NORTH HARBOUR MARINA SIX MAPS AERIAL IMAGE & DA OVERLAY PLAN

RE: DA2024/1216 - North Harbour Marina

NORTH HARBOUR MARINA – DA CONCERNS – FURTHER SUBMISSION

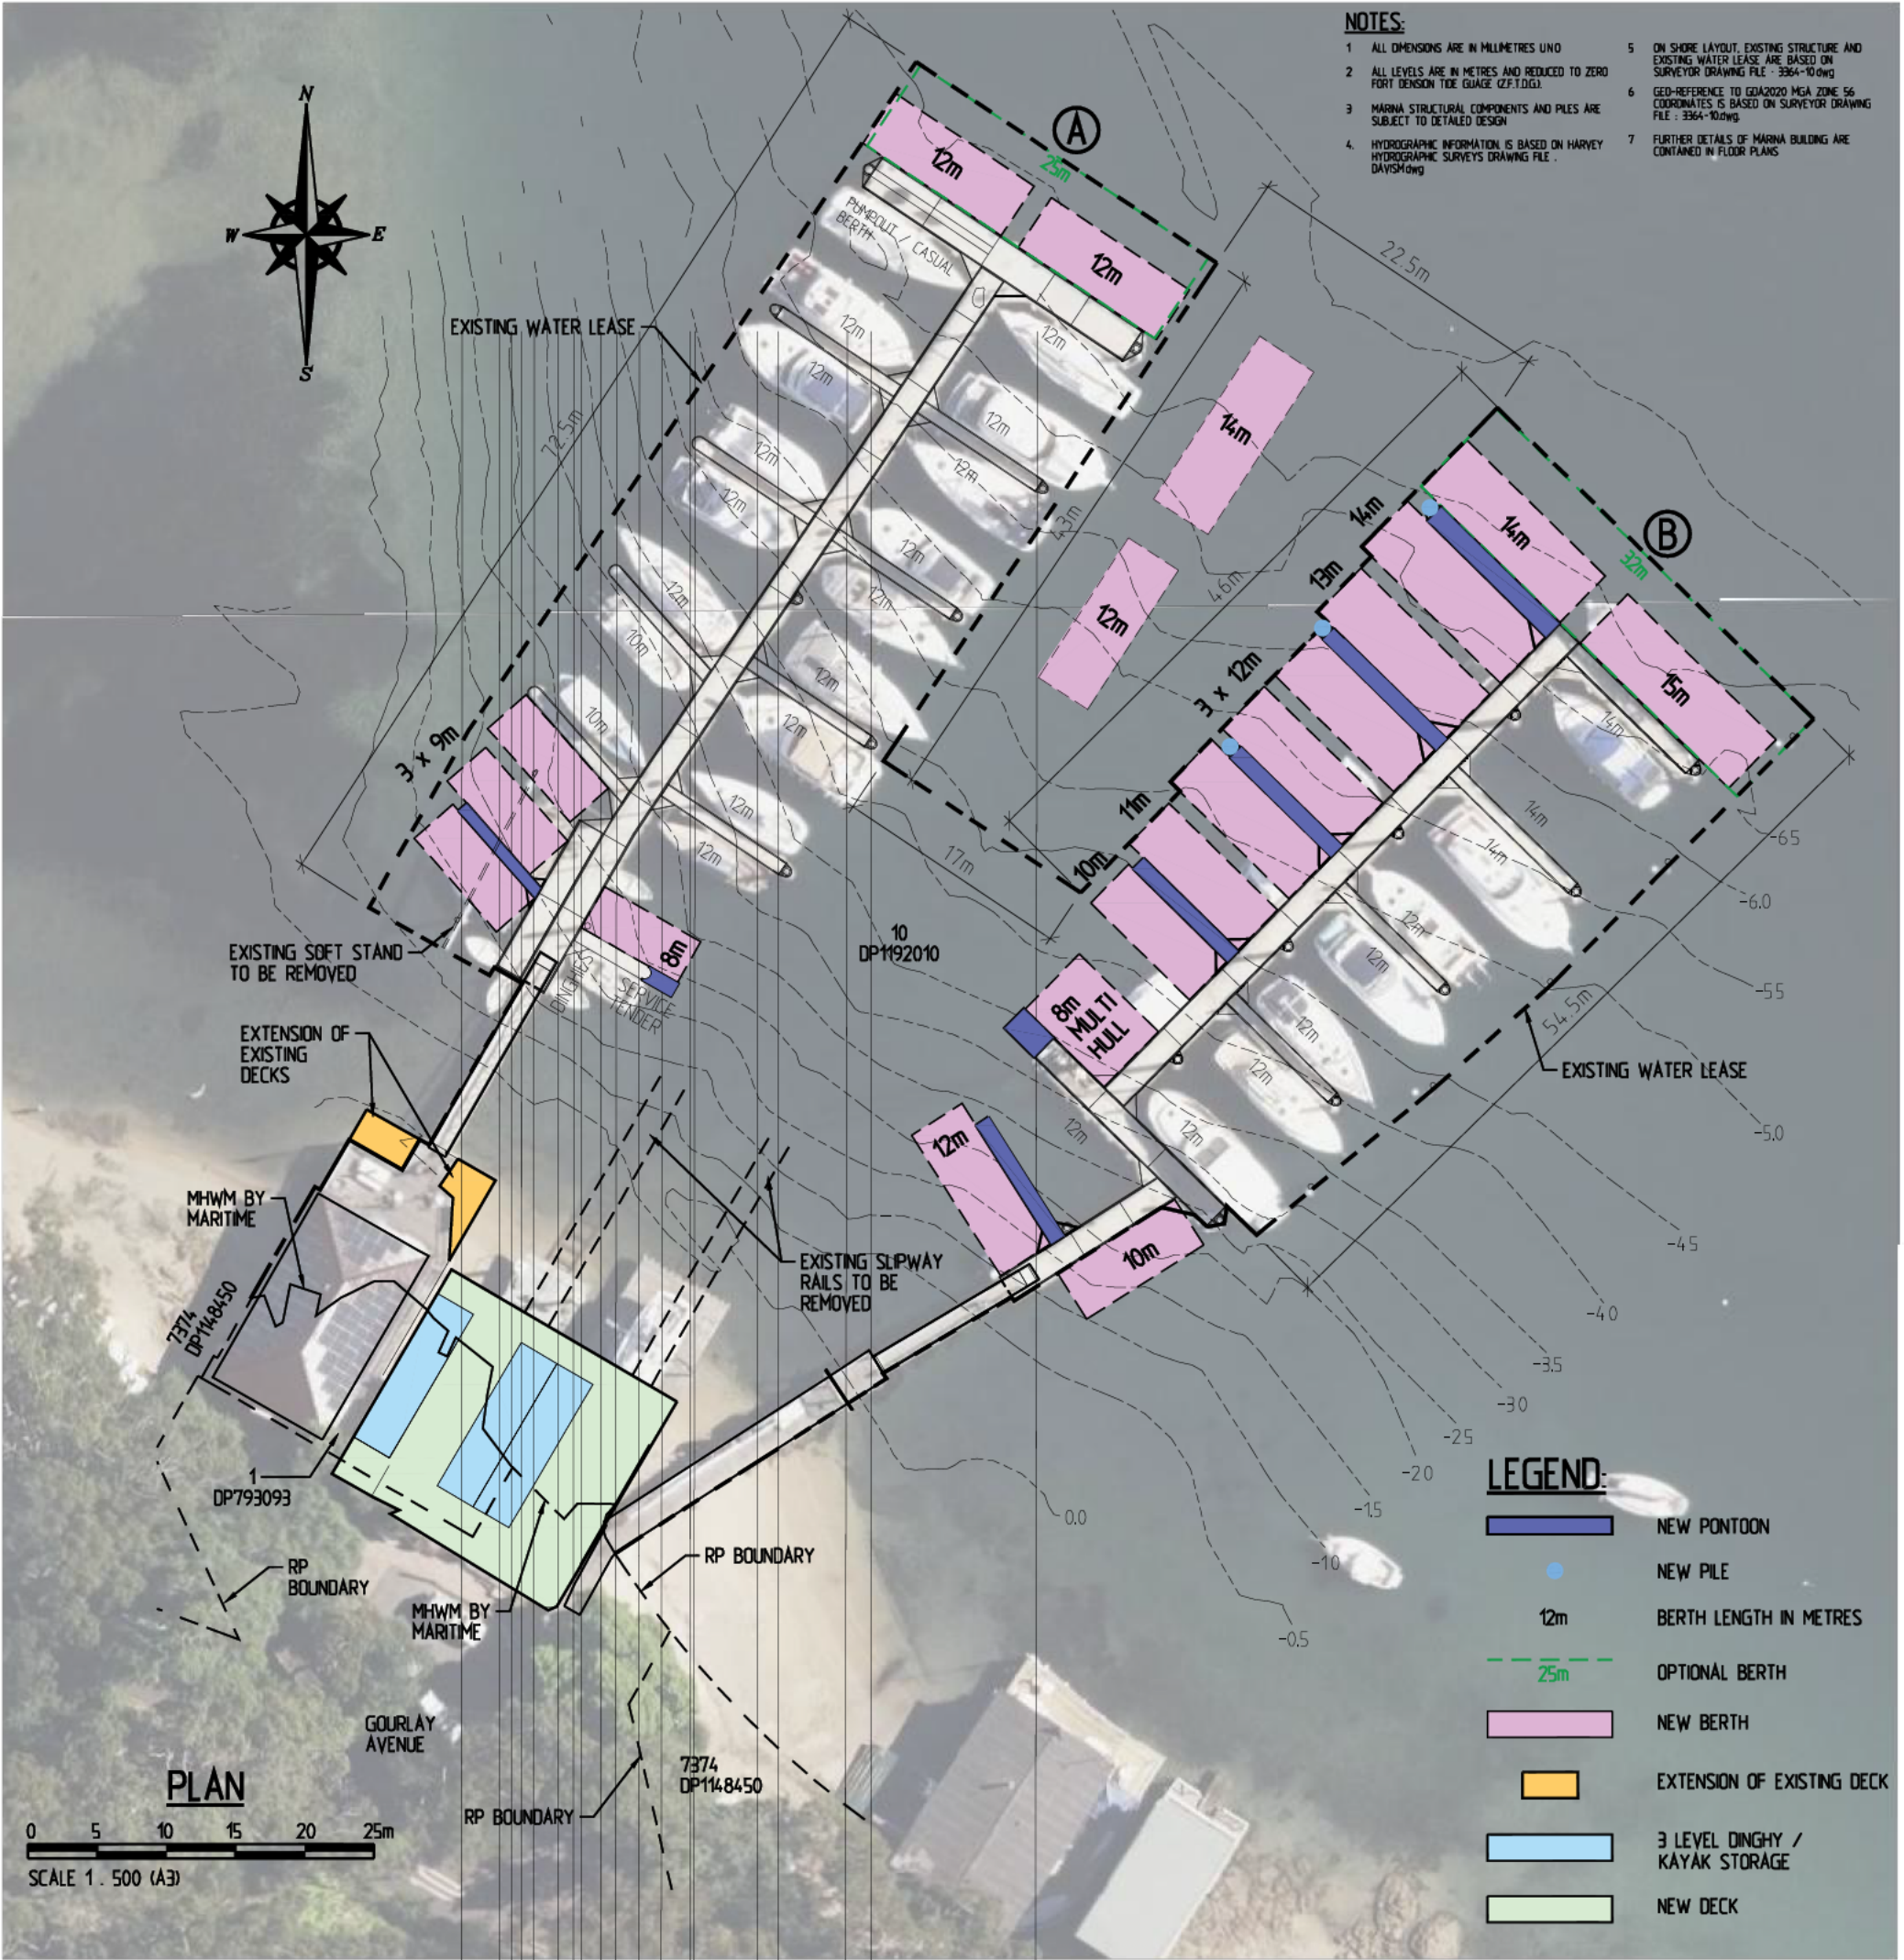
I had previously expressed doubts as to the accuracy of the plan. Detailed analysis suggests the distance between the arms is shown accurately but confirms that it does not meet the Australian Standard (AS3962).

As the attached plan shows the minimum 20 meter width is not met for almost all of the berths between the arms. The 25 metre preferred width is not met anywhere. Moreover, when the boats of the specified lengths are in their berths they almost all protrude into the interior channel further reducing the already drastically inadequate width.

As the plan shows most vessels of the size specified would protrude beyond the leased area line into the interior channel. Despite the fall-back document circulated by the applicant (which was previously provided in my supplementary submission on 28 October 2024), the applicant is seeking 18 additional berths, not 9 as suggested.
